MUNICIPAL CORPORATION
KARACHI.

With reference to your application with plan for building
on plot No. 36/6 Sheet No. JM 3, Jamshed Quarter received in this
office on 28. 3. 1934, I have to inform you that the said plan
approved and permission to build in accordance therewith is hereby granted.
The building must be erected in conformity with the Bye-laws and rules of
the Karachi Municipal Corporation.

with a plan for the proposed building/additions and alterations on plot
No. 36/6, Survey Sheet No. J.M.3, Jamsheed Quarter

PLAN
SHOWING PROPOSED BUNGALOW
ON PLOT N^o 36/6. SHEET N^o J.M.3.
FOR
THE HYDERABADI AMIL CO-OPERATIVE
HOUSING SOCIETY
SCALE 8 FT. TO 1 IN.

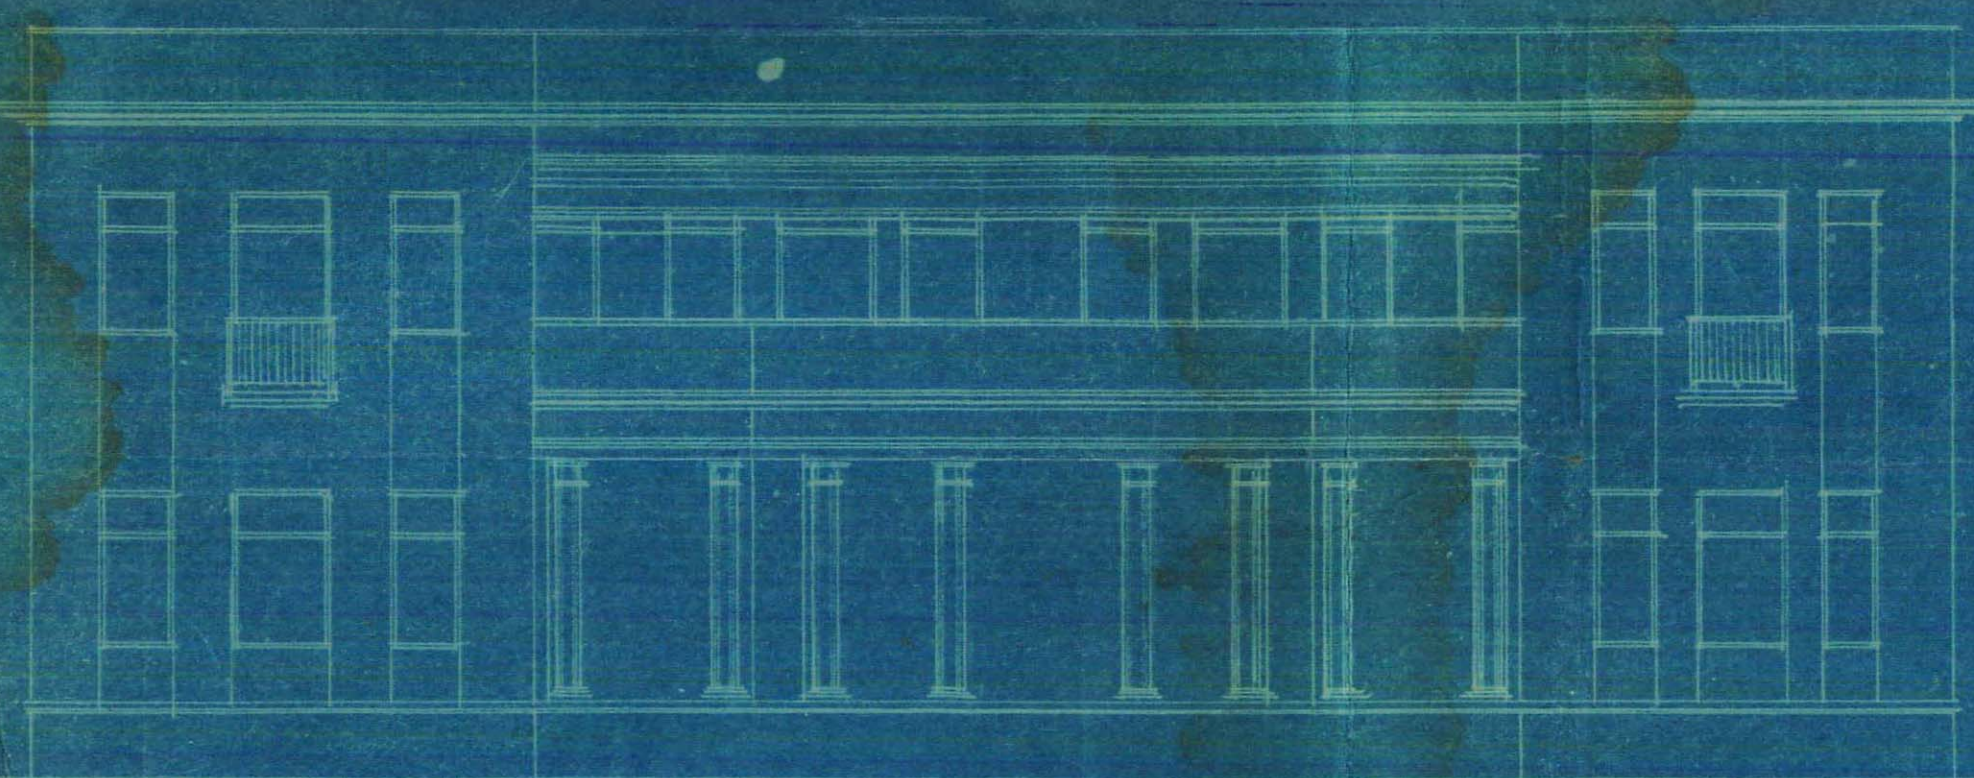
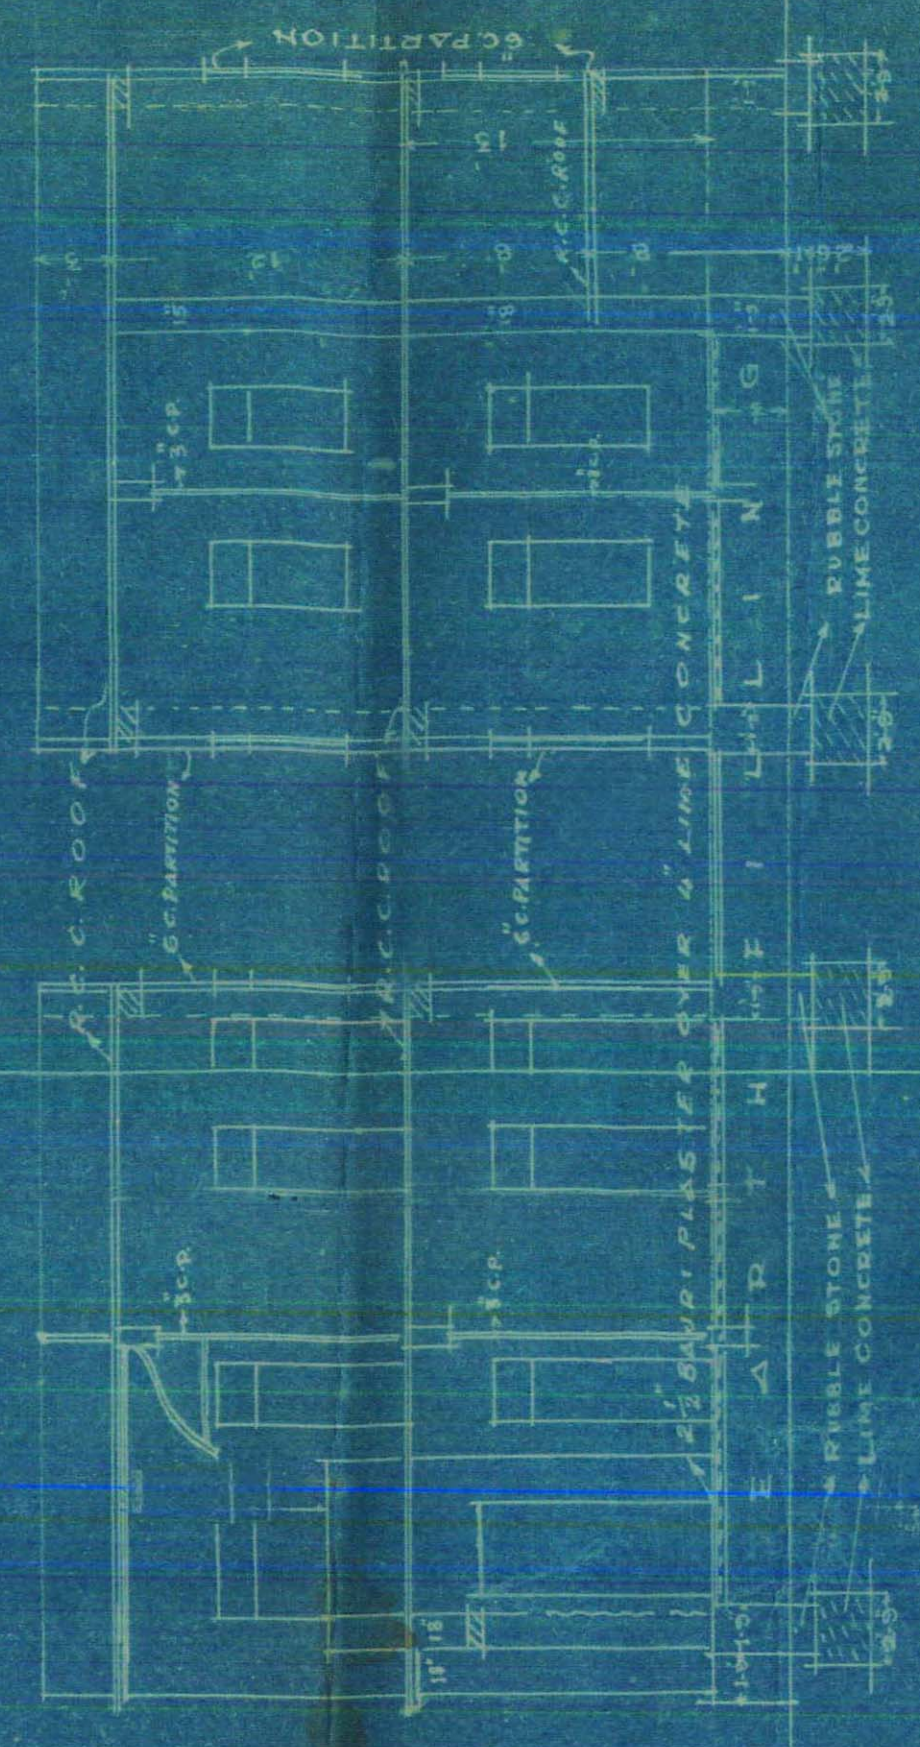
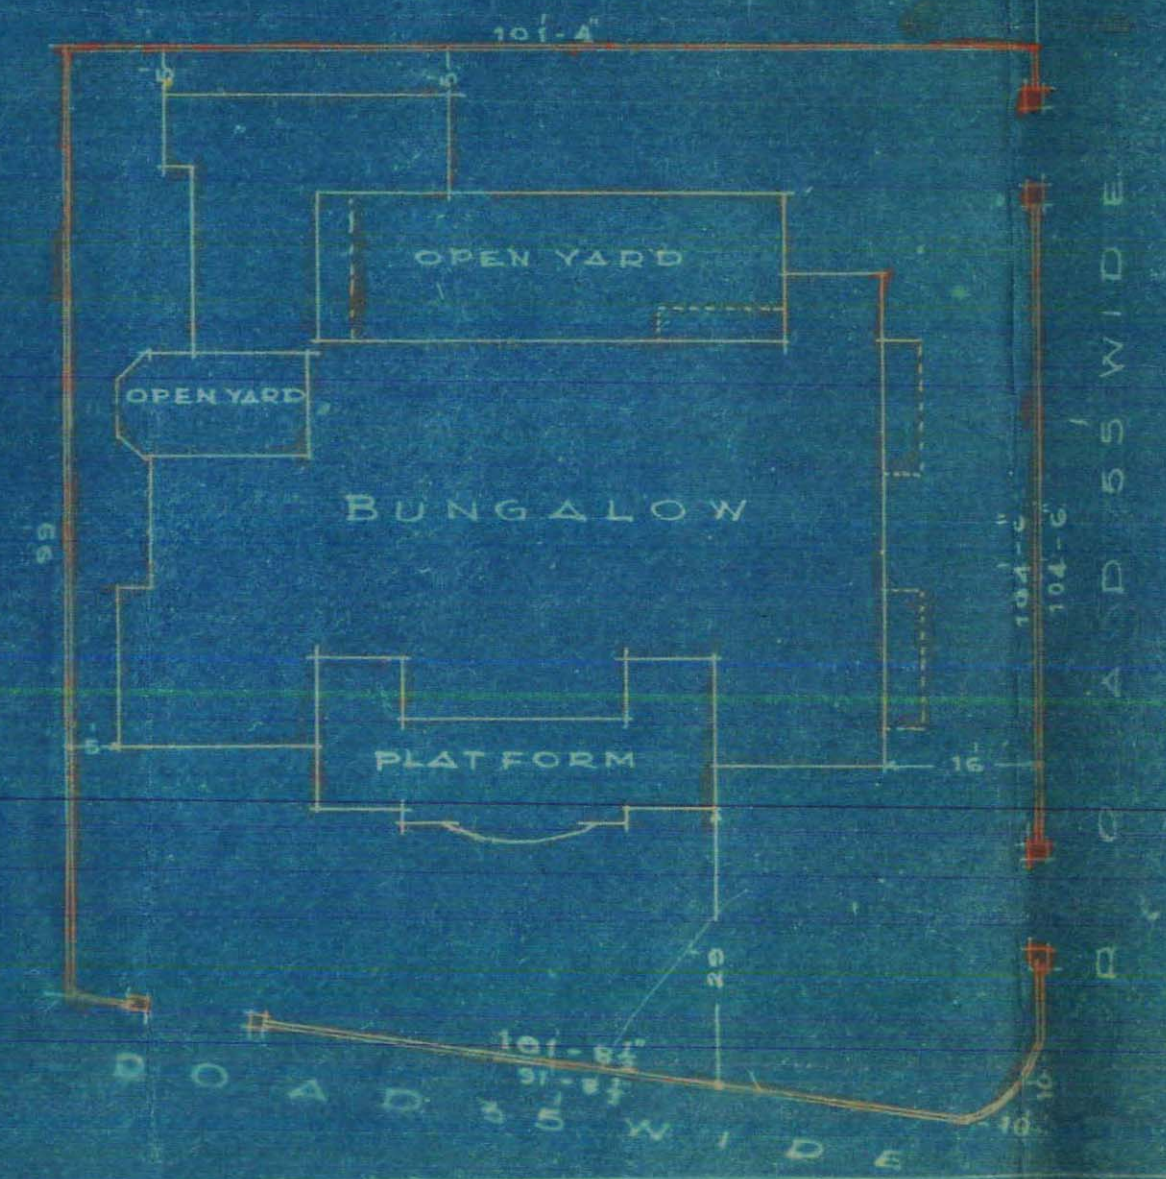
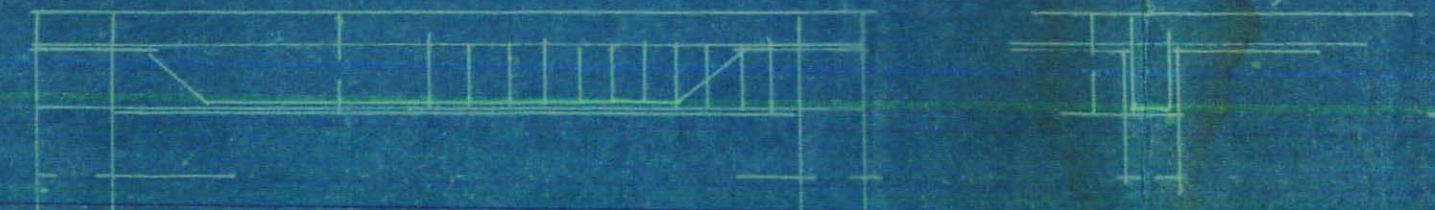
1. The various structures are not completely dimensioned with the result that the built up area calculations cannot be checked. (Dining Hall & Drawing Room not completely specified. Large gallery passage near the hall projections etc)
2. Rec beams & slab, pillars with reinforcement be specified
3. Thin exterior walls must be 6" CP.
4. Section requires correction.
5. Court yard walls be specified with thickness & height
6. Bay windows must be specified in their dimensions
7. gallery passages have to be taken in built up area.
8. WCs cannot be allowed as there is no drainage.
9. Landing for stairs be shown
10. It must be shown how main staircase for out house is supported
11. Section through the garage with separate loft plan be given

- ✓ 1. The various structures are not completely dimensioned with the result that the built up area calculations cannot be checked (dining hall and drawing room not completely specified. Gallery passage near the bath projections etc)
- ✓ 2. R.C.C. beams and slab pillars with reinforcement be specified.
- ✓ 3. Thin external walls must be 6" c.p.
- ✓ 4. Section requires correction.
- ✓ 5. Court yard walls be specified with thickness and height.
- ✓ 6. Bay windows must be specified in dimensions.
- ✓ 7. Gallery passages have to be taken in built up area.
- ✓ 8. W.c.s. cannot be allowed as there is no drainage
- ✓ 9. Landing for round stairs be shown.
- ✓ 10. It must be shown how main staircase for out houses is supported.
- ✓ 11. Section through the garage with separate loft plan be given.
- ✓ 12. W.C.s. cannot be permitted as no drainage is laid in this area.

1. The copy on cloth now submitted is quite indistinct and require correction.
2. Till this is done the plans could not be approved.

*Grass room
must be detached from
the main Bldg & 8' is
too small a height for a
locality like J.M. 3.*

*Submitted to L.M.O.A with the report that the
is no objection to plan as amended. The garage is made 25'-
and the loft 12'-6" x 9'. The design is as personally
agreed by the architect & the owner with you.*
